2 Type of change

- Change of fuse approval marking

Product Change Notification					PCN SPT 3.6x10 - change of approval logo		
owner	creation date	release date	released by	change order	rev	page	D10-102-775
kooka	07.08.2026	10.08.2026	jingkl		A	1 of 2

3 Detailed description of change

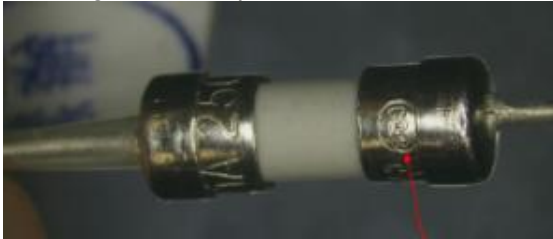
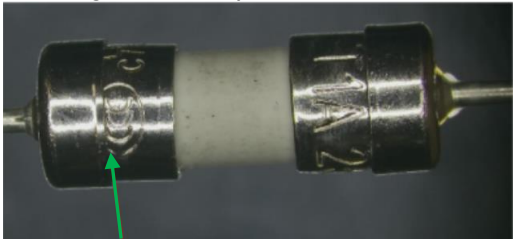
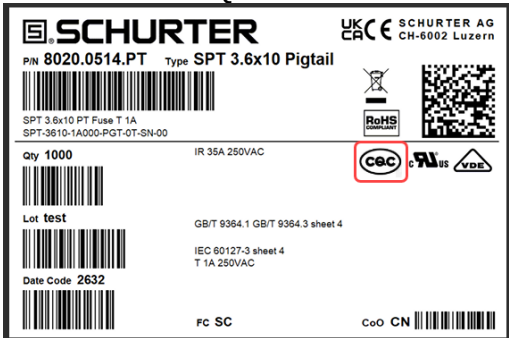
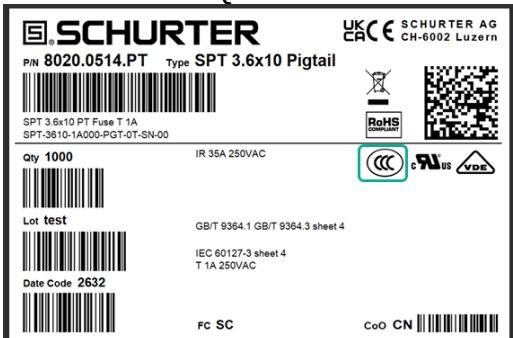
Current	After
CQC logo on the cap: 	CCC logo on the cap: 
Label on the SPQ: 	Label on the SPQ:

- Requested by CCC: The series of product shall be marked with CCC because of the CCC self-declaration.

☐ Form	No change
☐ Fit	No change
☐ Function	No change
☐ Manufacturing	No change
☒ Label	Inform incoming inspection about the changes on fuse and label .
☐ Packaging	No change
